Access Compliance Report

Public Rights-of-Way

(Curb Ramps)

Intersection ID: 6233	Main Street: JUNIPER_DR	Cross Street: MILHAVEN_LN	Location: SW
ADA ID: CB7D573EBF91	Ramp Type: Directional1	Initial Pass/Fail: Fail	Overall Compliance: No
		Severity Score: 25

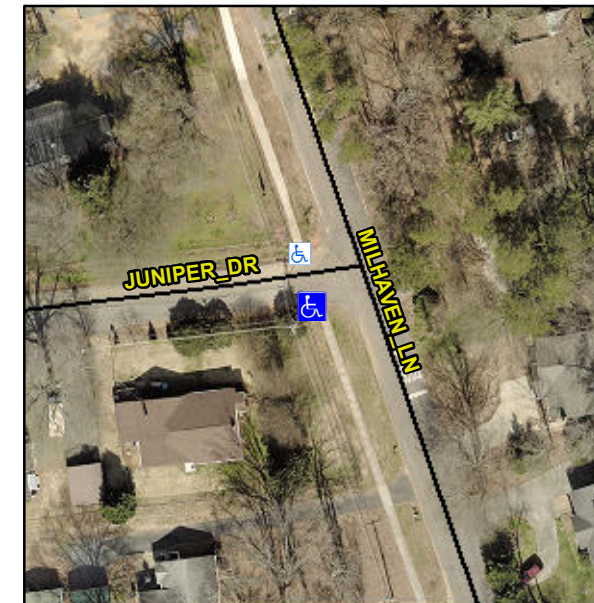
NO CURB

R304.2.2, R304.5.3

Compliance	Description	Data	Compliance	Description	Data
N/A	Ramp Length (in)	26.0	N/A	Grade Break?	N/A
Yes	Ramp Width (in)	60.0	N/A	Grade Break Slope (%)	0.0
No	Ramp Slope (%)	10.0	N/A	Grade Break XSlope (%)	0.0
No	Ramp XSlope (%)	6.5			
N/A	Flare Type LT	N/A	N/A	Flare Type RT	N/A
N/A	Flare Slope LT (%)	N/A	N/A	Flare Slope RT (%)	0.0
N/A	Flare Traversable LT?	N/A	N/A	Flare Traversable RT?	N/A
N/A	Landing Length (in)	0.0	N/A	DWS Provided?	N/A
N/A	Landing Width (in)	0.0	N/A	DWS Contrast?	N/A
N/A	Landing Slope (%)	0.0	N/A	DWS Length (in)	N/A
N/A	Landing X Slope (%)	0.0	N/A	DWS Full Width?	N/A
N/A	Landing Curb? (Y/N)	N/A	N/A	DWS Offset LT (in)	N/A
N/A	Shared Landing?	N/A	N/A	DWS Offset RT (in)	N/A
N/A	Gutter Ponding?	0.0	N/A	Gutter Slope (%)	N/A
N/A	Gutter Lip Ht (in)	0.0	N/A	Gutter X Slope (%)	N/A
N/A	Painted X Walk1?	No		Road Slope (%)	9.2
	X Walk 1 Direction	To N		Road X Slope (%)	6.6
	X Walk 1 Width (in)	N/A		Clear Space?	N/A

Remove & Replace Entire Ramp.
